BROWNS FERRY NUCLEAR PLANT (BFN) - UNITS 2 AND 3 - TECHNICAL SPECIFICATIONS (TS) CHANGE TS-418 - RESPONSE TO REQUEST FOR ADDITIONAL INFORMATION SPSB-A.11 REGARDING EXTENDED POWER UPDATE - CREDIT FOR NET POSITIVE SUCTION HEAD (TAC NOS. MC3743 AND MC3744)

ENCLOSURE 1
TENNESSEE VALLEY AUTHORITY (TVA)
BROWNS FERRY NUCLEAR PLANT (BFN) UNITS 2 AND 3
RESPONSE TO NRC REQUEST FOR ADDITIONAL INFORMATION
REGARDING PROPOSED TECHNICAL SPECIFICATION (TS) TS-418
EXTENDED POWER UPRATE - CREDIT FOR NET POSITIVE SUCTION HEAD

NRC REQUEST SPSB-A.11

FIGURE 1
NET POSITIVE SUCTION HEAD REQUIREMENTS FOR DESIGN BASIS LOSS OF COOLANT ACCIDENT – SHORT TERM

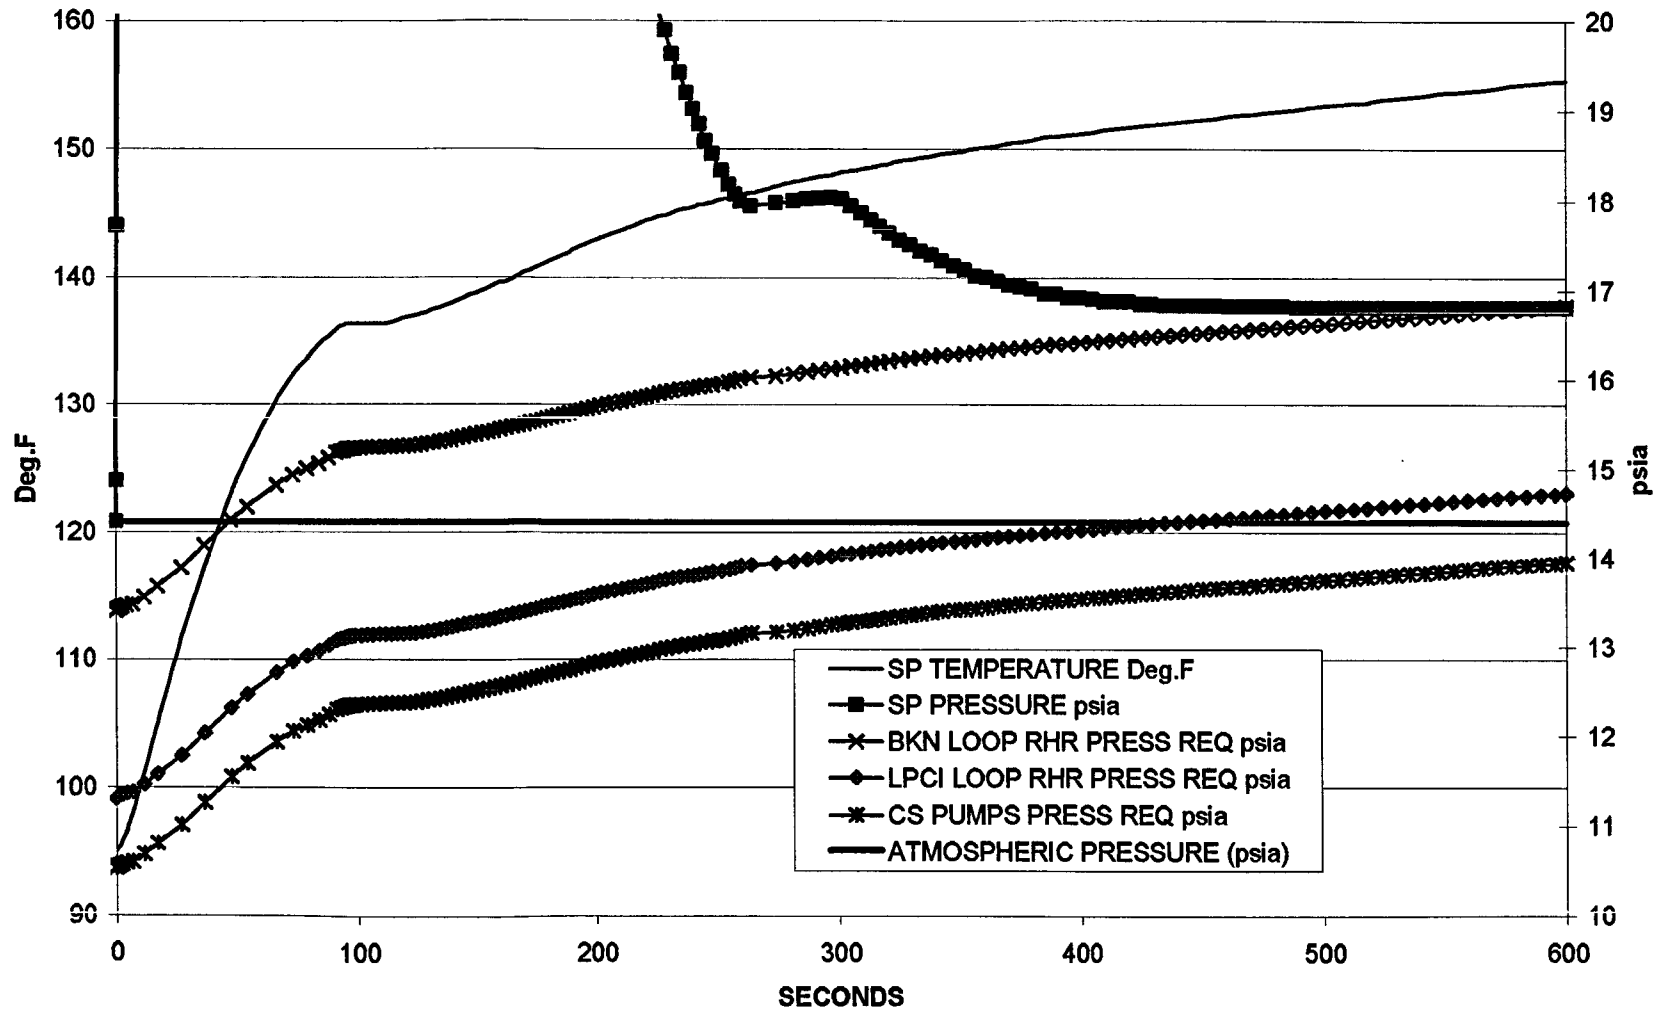
The bounding design basis event for determining NPSH margin is a double ended recirculation discharge line break. This event results in maximum suppression pool temperature and maximum total pump flow. The discharge line break is chosen because the low system resistance on the broken line produces the most limiting flow and NPSH for two RHR pumps which are assumed to be pumping into the broken line inside containment. At the beginning of the event, four RHR pumps and four Core Spray pumps start automatically and align to inject to the Reactor Pressure Vessel (RPV). Two RHR pumps inject to the RPV at 10,000 gpm each, two RHR pumps inject through the broken line into the containment at 11,000 gpm each (greater than design flow), and four Core Spray pumps inject to the RPV at 3,125 gpm each. This mode of operation is assumed for 10 minutes consistent with not crediting operator action for 10 minutes. ECCS strainers are assumed to accumulate the maximum equilibrium debris load. During this time suppression pool temperature reaches 155.4°F and only the RHR pumps require credit for COP in order to have sufficient NPSH margin as shown in Figure 1.

COP was lost. Core Spray pumps do not require COP in the short-term (Refer to Figure 1). BFN Core Spray pumps are Sulzer-Bingham model 12x16x14.5 CVDS. Assuming no credit for COP, the Core Spray pumps used for long-term core cooling (>10 minutes) would be expected to operate between 27 feet and 22.6 feet of NPSH verses 27 feet used in NPSH calculations for approximately 13.4 hours as Suppression Pool temperature peaks above 175.8°F during the LOCA. In the unlikely event they become degraded, there is a reasonable likelihood that the affected pumps would still be able to function. In addition, only one of the two Core Spray loops is required to be operated for adequate core cooling and the non-operating Core Spray loop would be available to operators if the operating loop failed after some time period. RHR pumps would also be available in the LPCI mode for core cooling in conjunction with their suppression pool cooling function should all Core Spray pumps become unavailable. COP is not required for RHR pumps in the long-term scenario. Therefore in the unlikely event that COP was lost in the long-term LOCA, the decay heat removal and core cooling functions would be maintained.

FIGURE 2
NET POSITIVE SUCTION HEAD REQUIREMENTS FOR DESIGN BASIS LOSS OF COOLANT ACCIDENT – LONG TERM

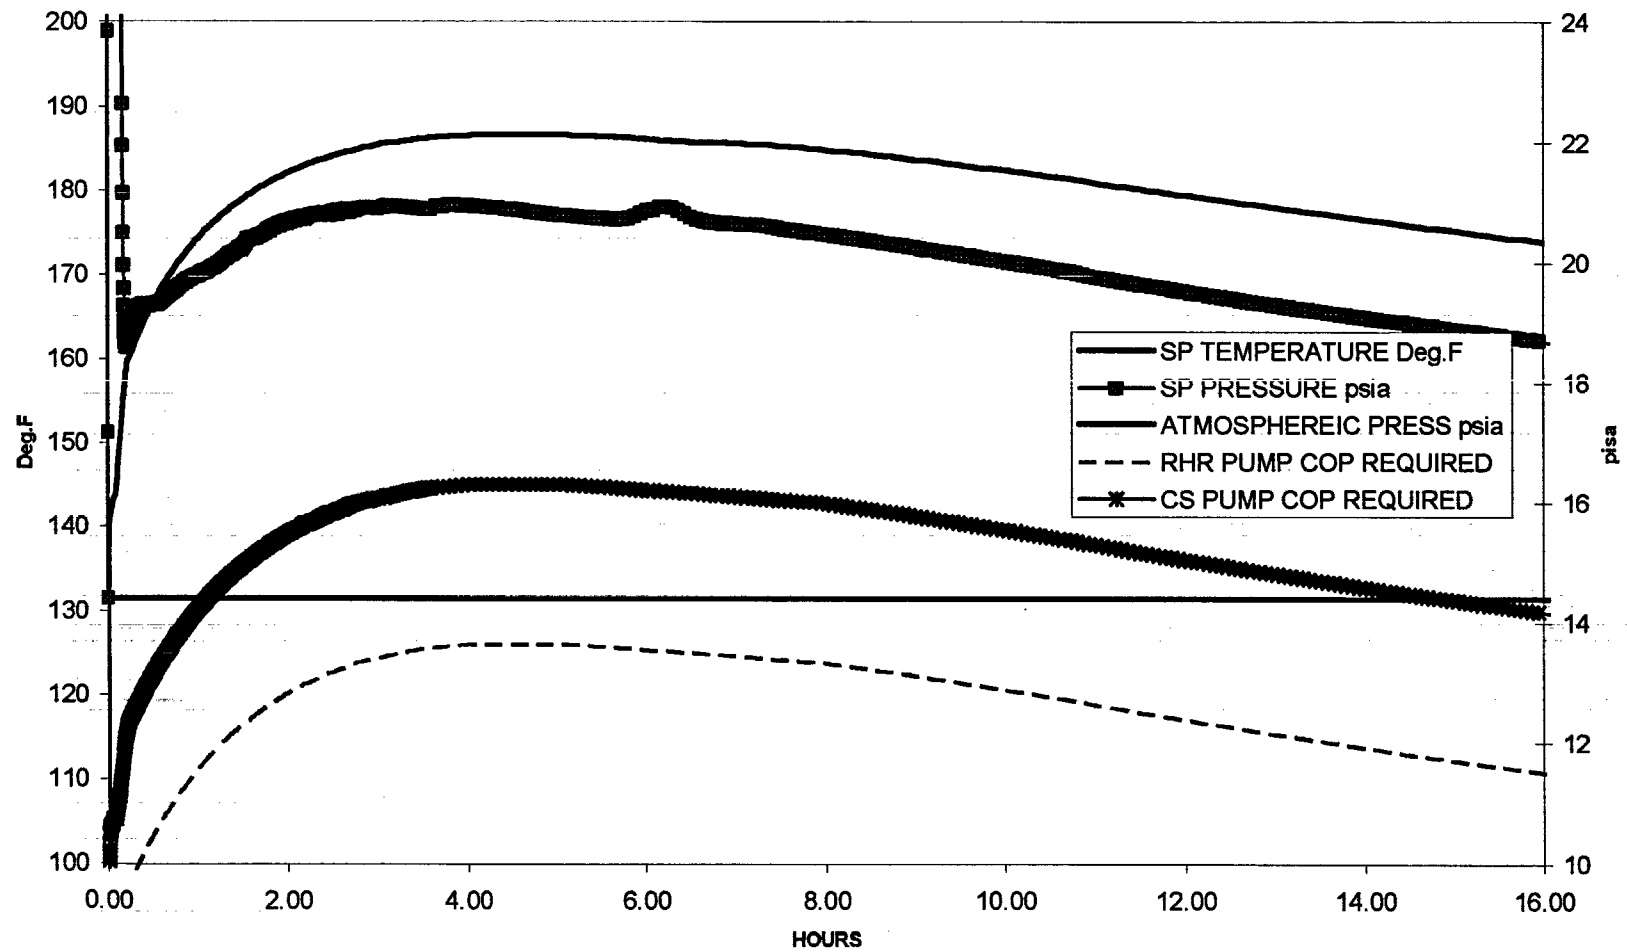
At 10 minutes, operator action is assumed which places the minimum complement of ECCS pumps into modes required for long term cooling. Two Core Spray pumps (one loop) at design flow of 3,125 gpm each are assumed for core cooling, and two RHR pumps in one loop in containment cooling mode at 6,500 gpm each are assumed for pool cooling. Containment spray mode of containment cooling is chosen to minimize available containment pressure. Only two of four RHR pumps are assumed for pool cooling due to single failure considerations. ECCS strainers are assumed to accumulate the maximum equilibrium debris load. During this time suppression pool temperature reaches 187.4°F and only the

two Core Spray pumps require credit for COP in order to have sufficient NPSH margin as shown in Figure 2.

FIGURE 3
CONTAINMENT OVERPRESSURE SENSITIVITY TO RESIDUAL HEAT REMOVAL SERVICE WATER (RHRSW) TEMPERATURE AND
NET POSITIVE SUCTION HEAD SENSITIVITY TO RHRSW TEMPERATURE

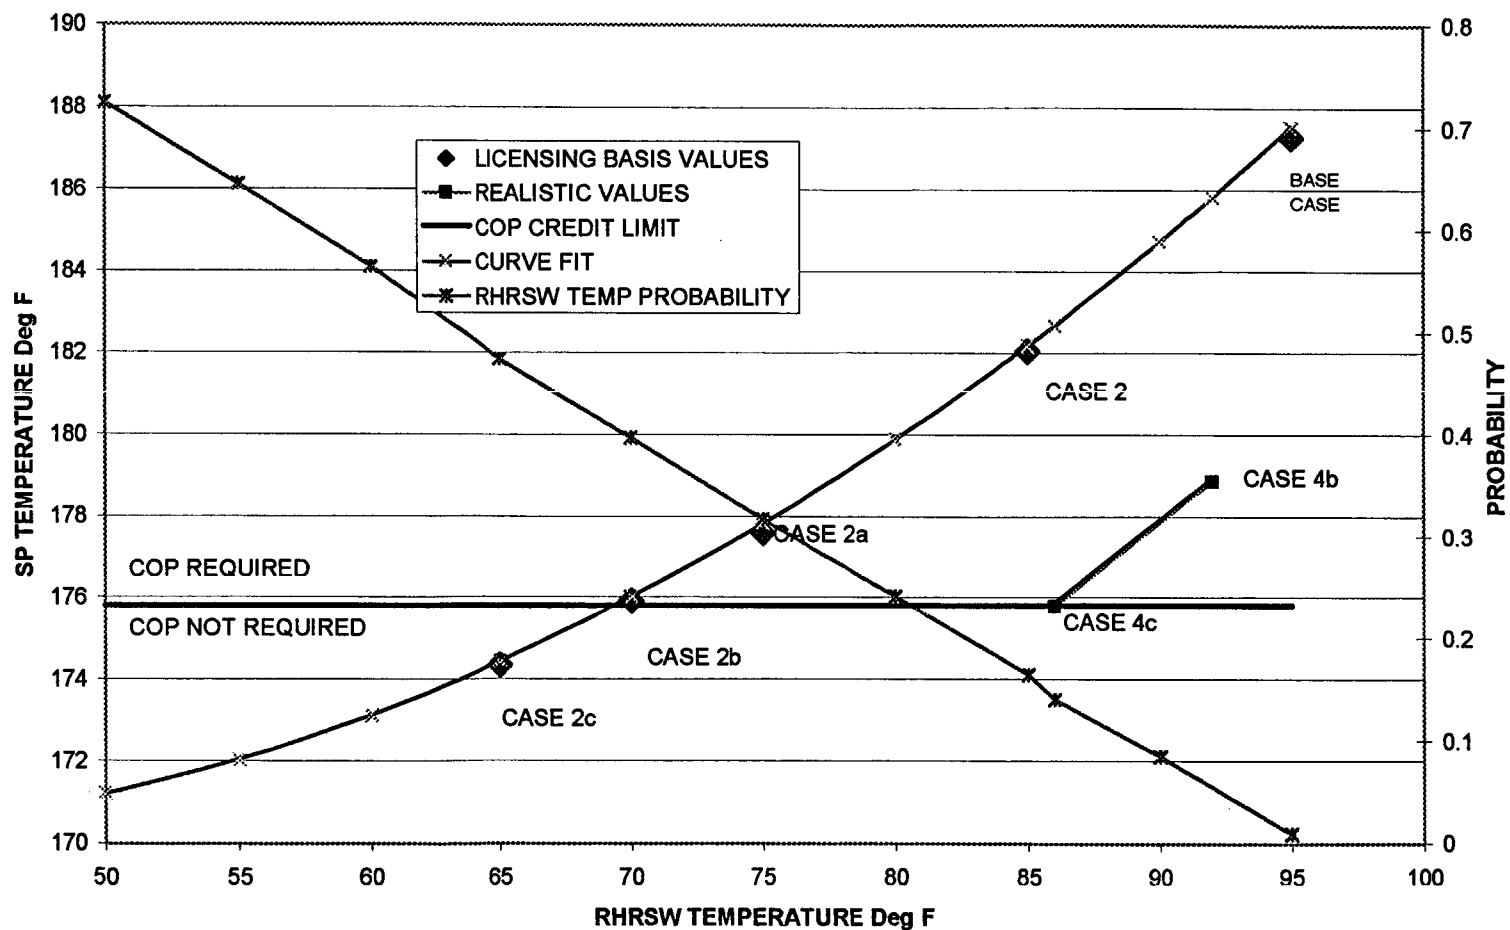
Suppression pool temperature response was examined as a function of RHRSW temperature which is a seasonal variable. Figure 3 shows Suppression Pool temperature as a function of RHRSW temperature using both licensing basis input values and realistic values. These analyses show that COP is not required for RHRSW temperatures 70°F or below assuming all design basis inputs and 86°F using realistic inputs. The probability of exceeding 70°F is 3.97E-1 and for 86°F is 1.40E-1.
